Subject ▶ Modification in design of Gear Housing

For Models ▶ HP2030, HP2031

► Current	► New
Gear Housing

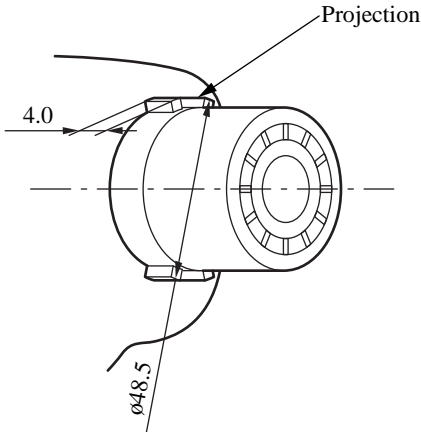
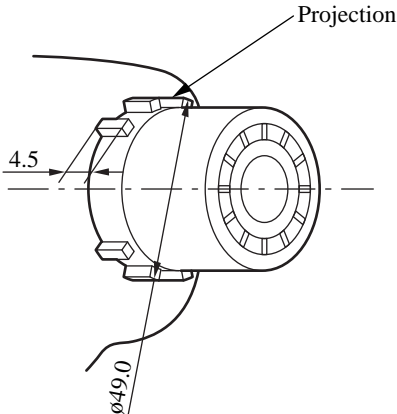
Description ▶ Gear Housing has been modified as follows:

- 1) Numbers of projections on the gear housing (for side-handle stops) have been changed from 4 to 8.
- 2) Dimension of each projection has been changed.

With this modification, strength of each projection has been increased.
